Service Bulletin

SEB92-8

HYDRAULIC LANDING GEAR HOSE REPLACEMENT

TITLE HYDRAULIC LANDING GEAR HOSE REPLACEMENT

Figure 1. 177RG Hydraulic Landing Gear Hose Replacement (Sheet 1 of 2)

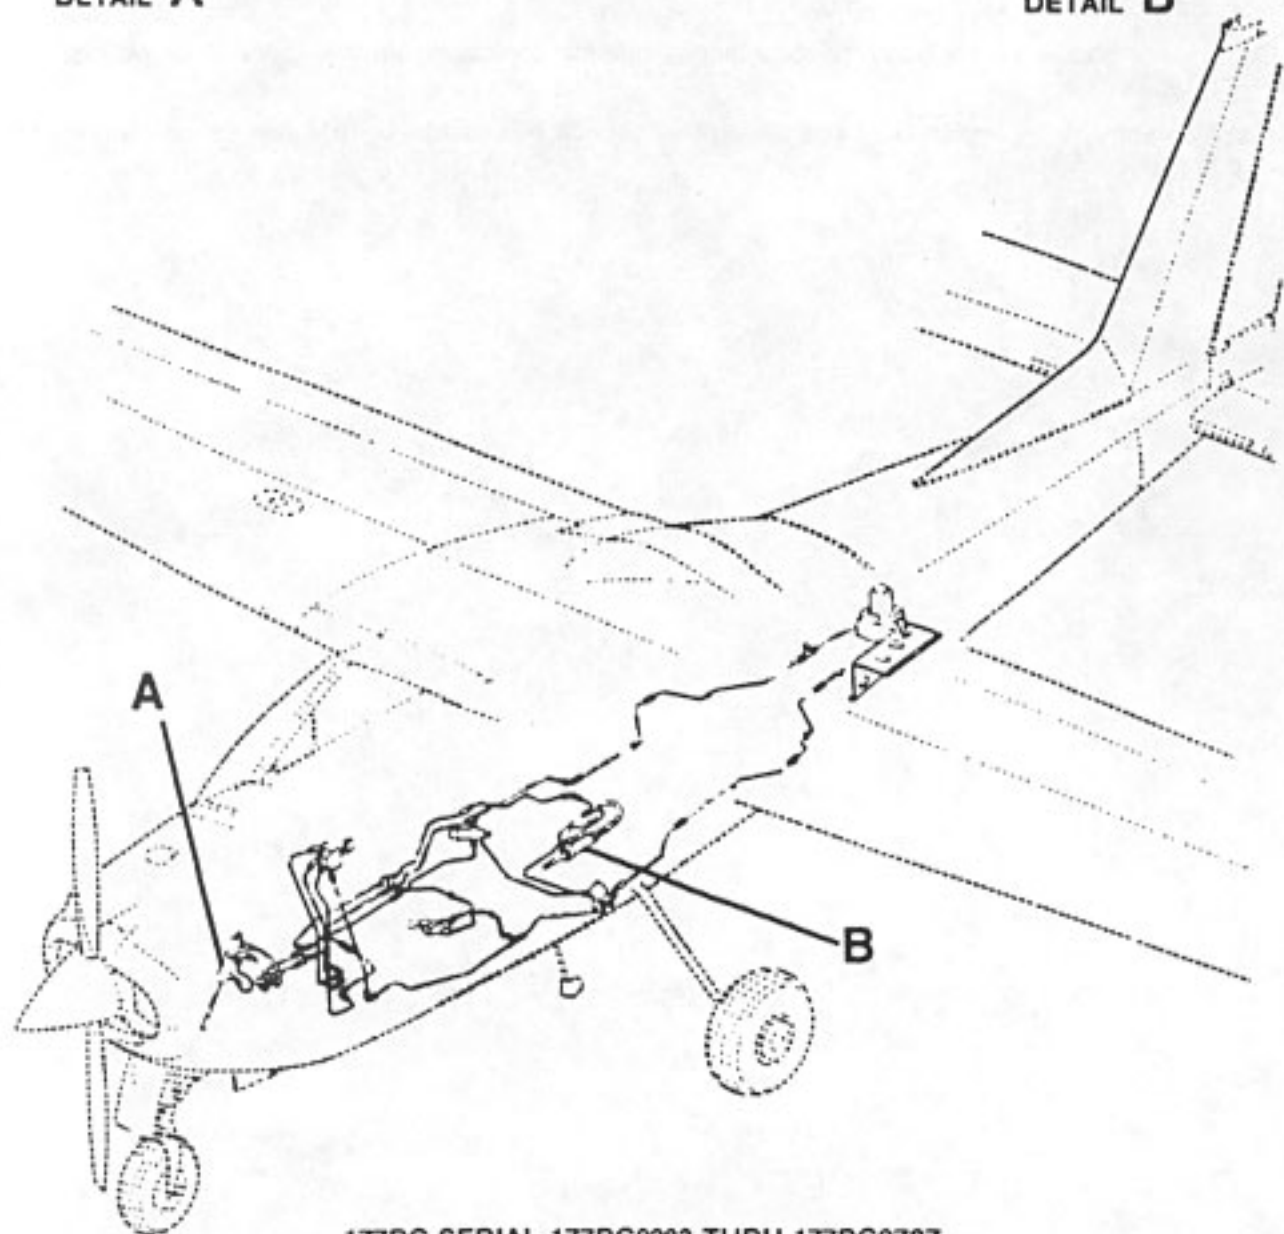
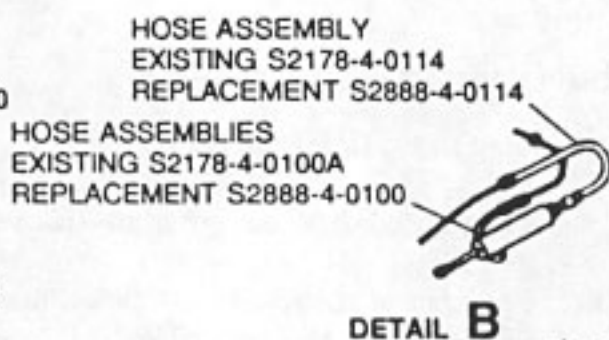
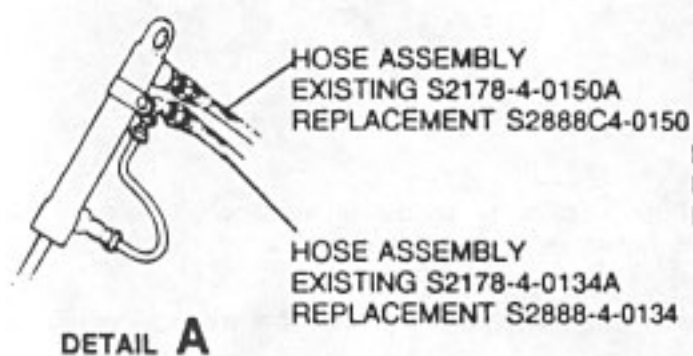
177RG SERIAL 177RG0283 THRU 177RG0787
F177RG SERIAL F177RG0063 THRU 177RG0138

Figure 1. 177RG Hydraulic Landing Gear Hose Replacement (Sheet 2)

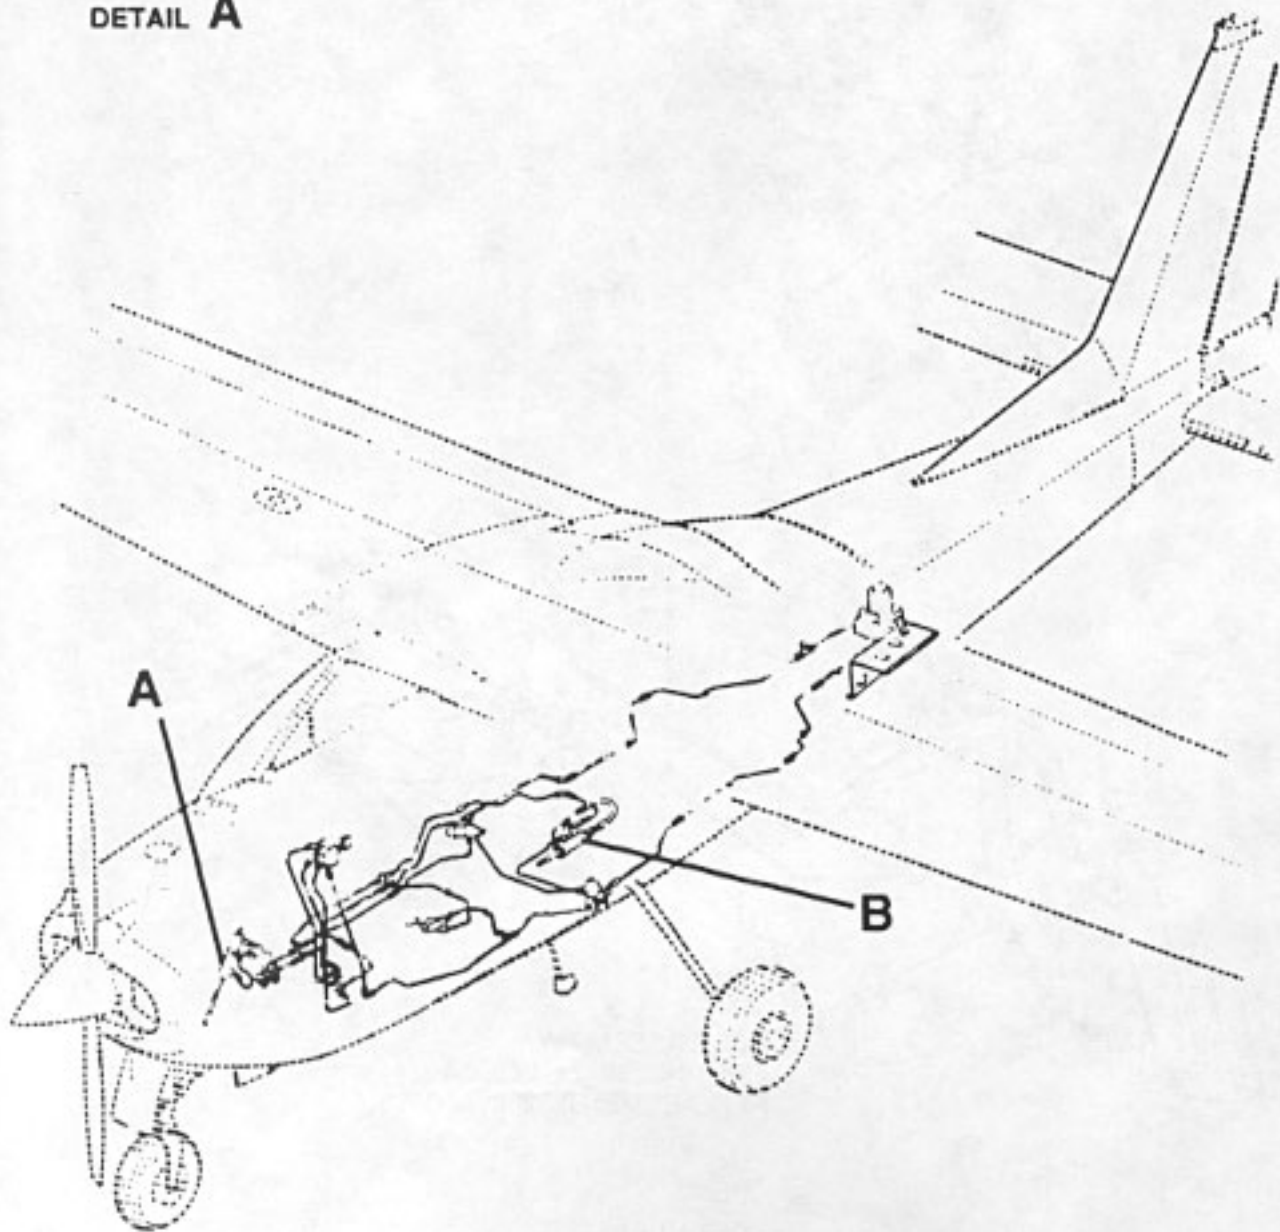
HOSE ASSEMBLY
EXISTING S2178-4-0150A
REPLACEMENT S2888C4-0150

HOSE ASSEMBLIES
EXISTING S2178-4-0104A
REPLACEMENT S2888-4-0104

HOSE ASSEMBLY
EXISTING S2178-4-0134A
REPLACEMENT S2888-4-0134

Figure 2. 210, T210 Hydraulic Landing Gear Hose Replacement (Sheet 1 of 8)

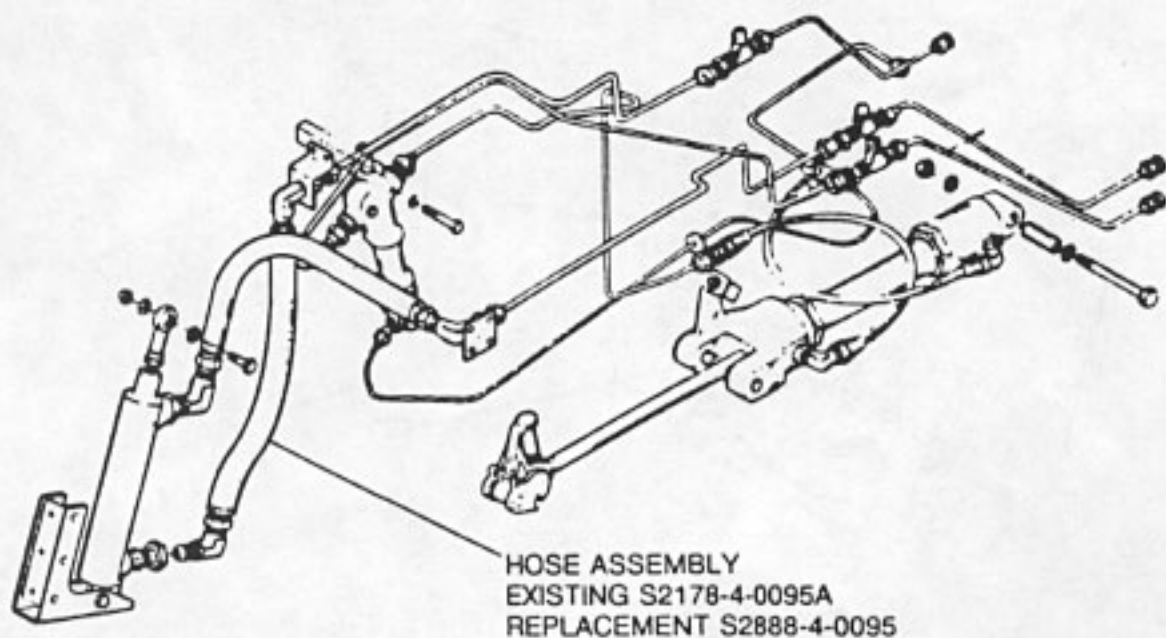
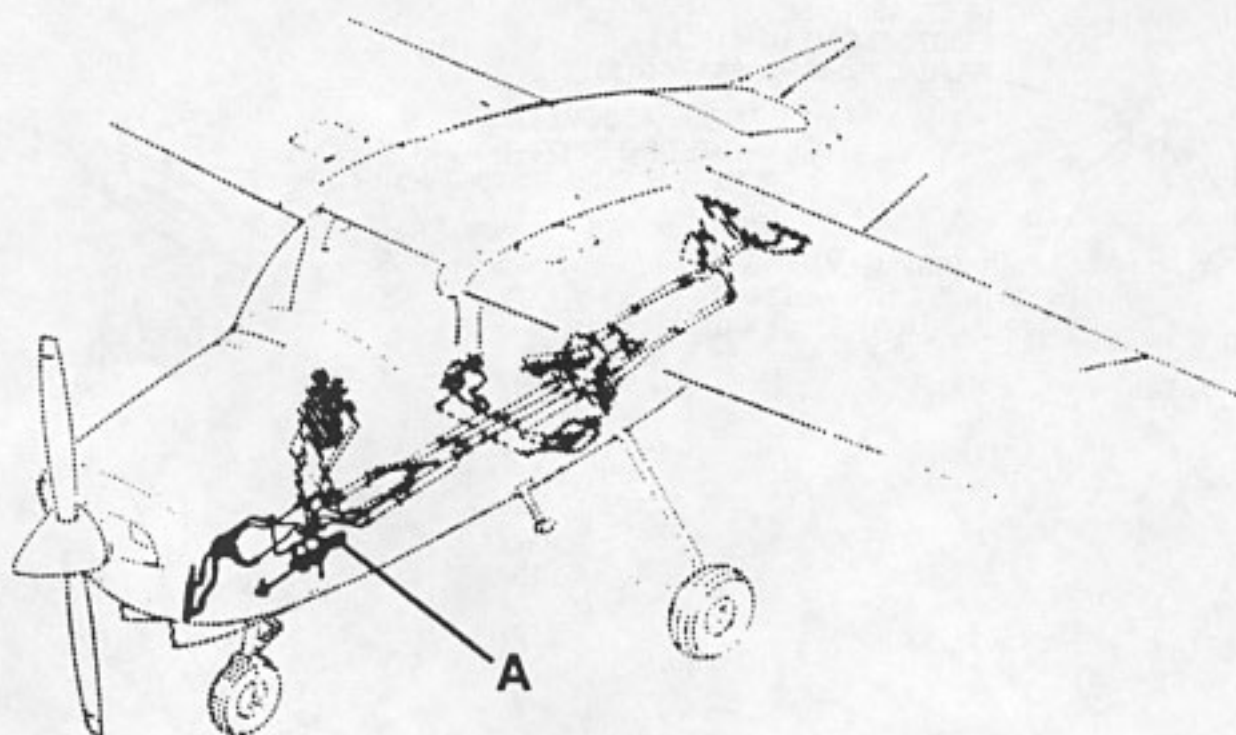
210 & T210 SERIAL 21059503 THRU 21061694

Figure 2. 210, T210 Hydraulic Landing Gear Hose Replacement (Sheet 2)

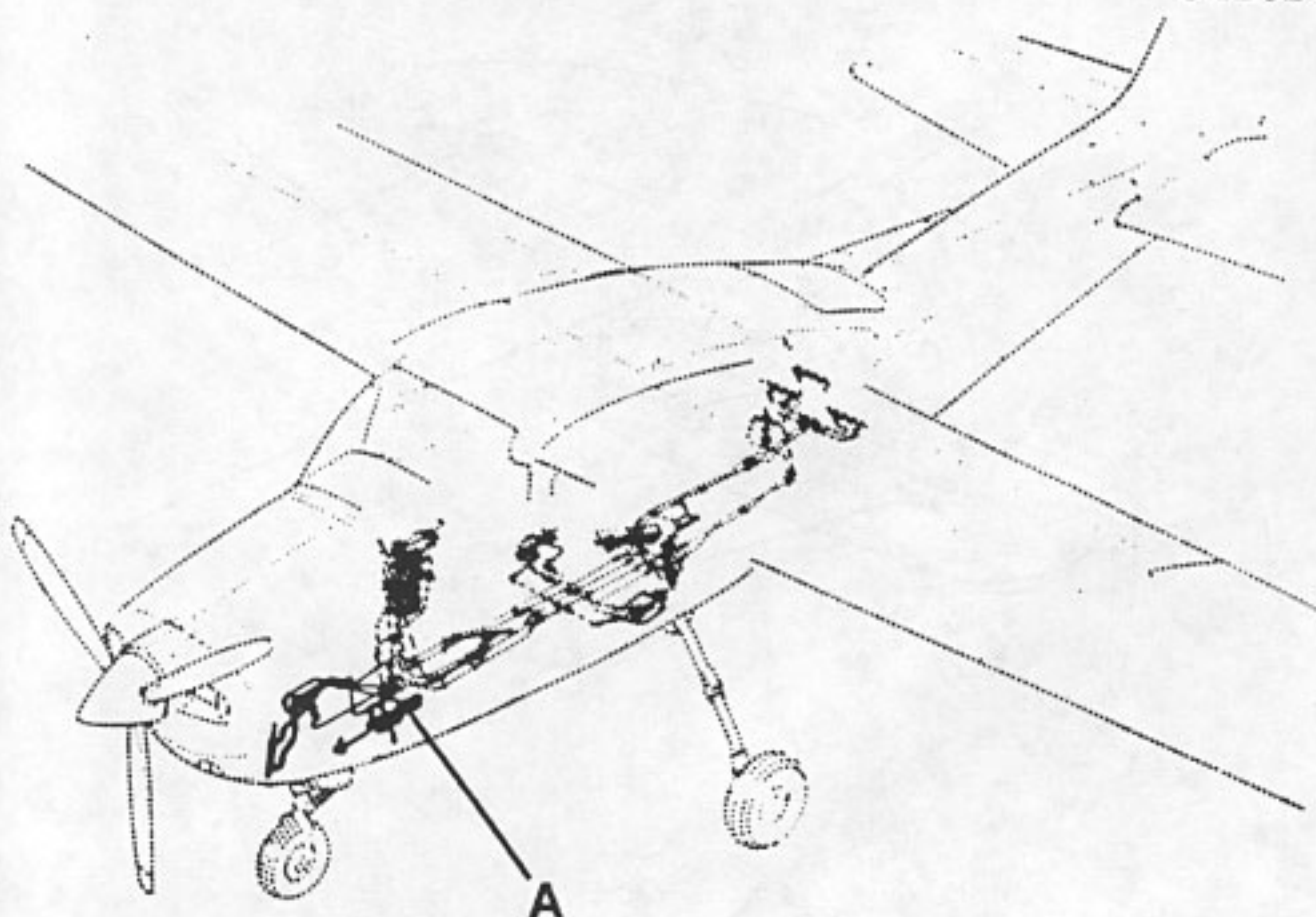
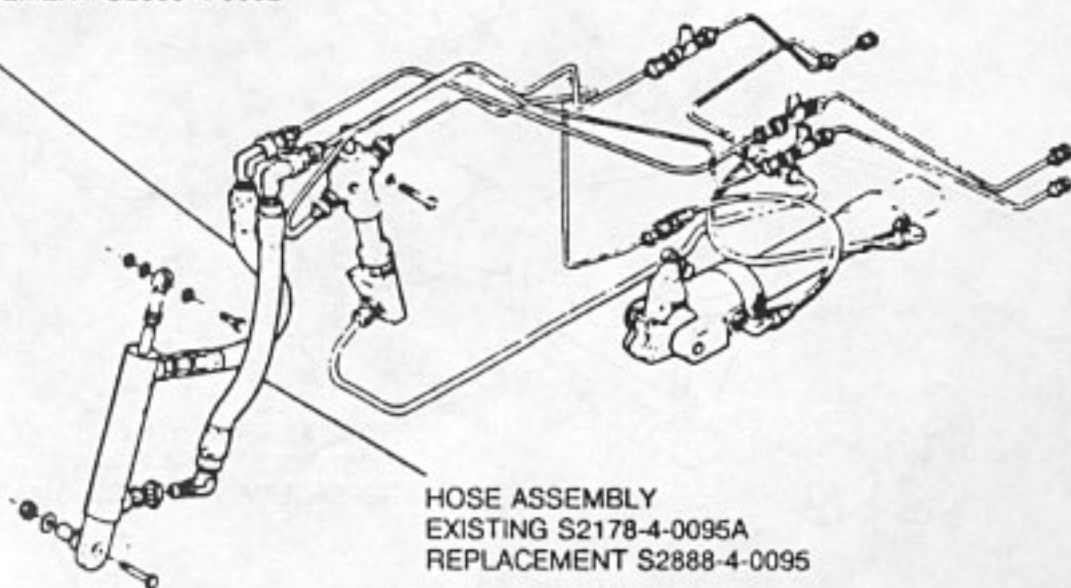
HOSE ASSEMBLY
EXISTING S2178-4-0082A
REPLACEMENT S2888-4-0082

HOSE ASSEMBLY
EXISTING S2178-4-0095A
REPLACEMENT S2888-4-0095

Figure 2. 210, T210 Hydraulic Landing Gear Hose Replacement (Sheet 8)

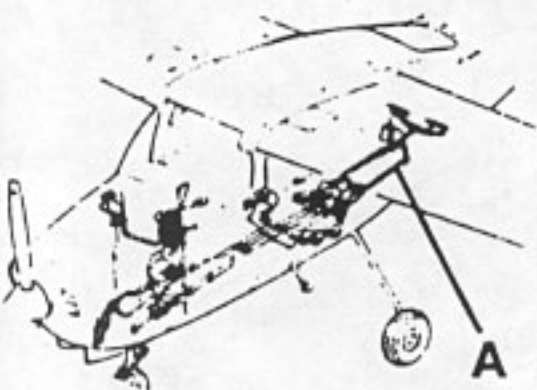
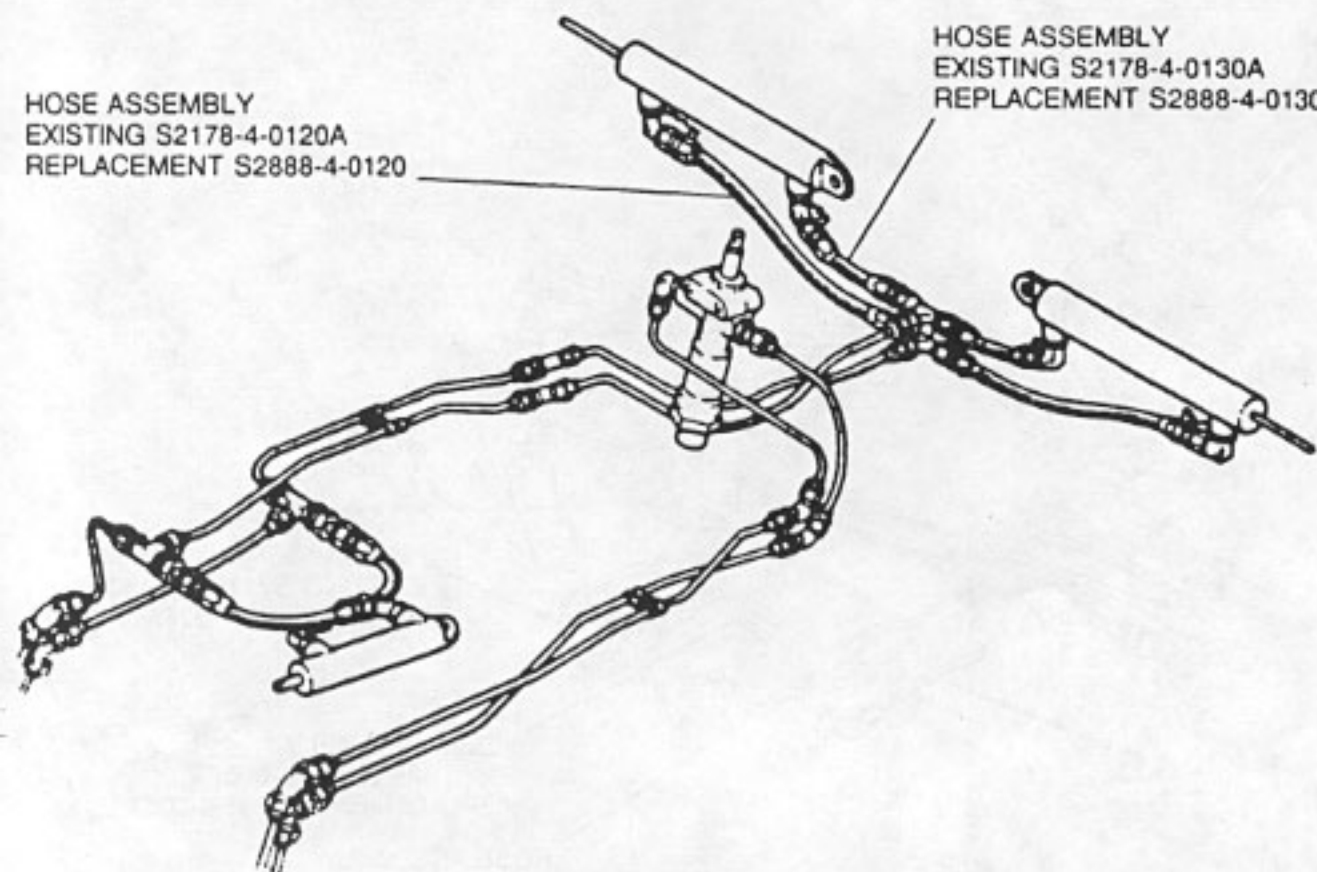
HOSE ASSEMBLY
EXISTING S2178-4-0120A
REPLACEMENT S2888-4-0120

HOSE ASSEMBLY
EXISTING S2178-4-0130A
REPLACEMENT S2888-4-0130

Figure 3. P210 Hydraulic Landing Gear Hose Replacement (Sheet 3)

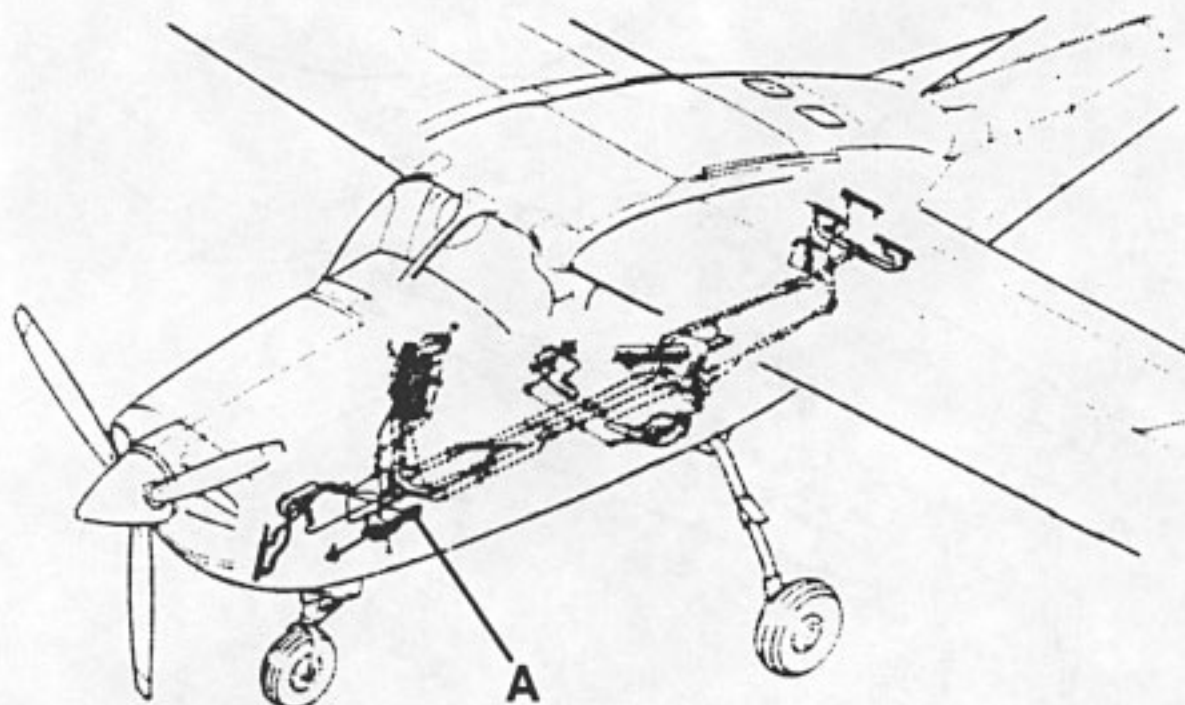
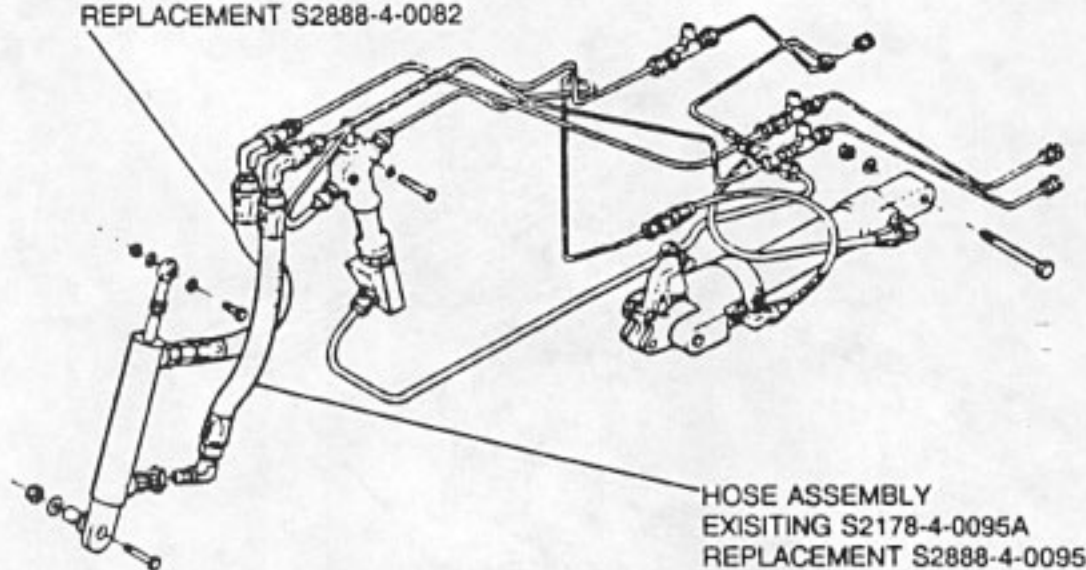
HOSE ASSEMBLY
EXISTING S2178-4-0082A
REPLACEMENT S2888-4-0082

HOSE ASSEMBLY
EXISTING S2178-4-0095A
REPLACEMENT S2888-4-0095
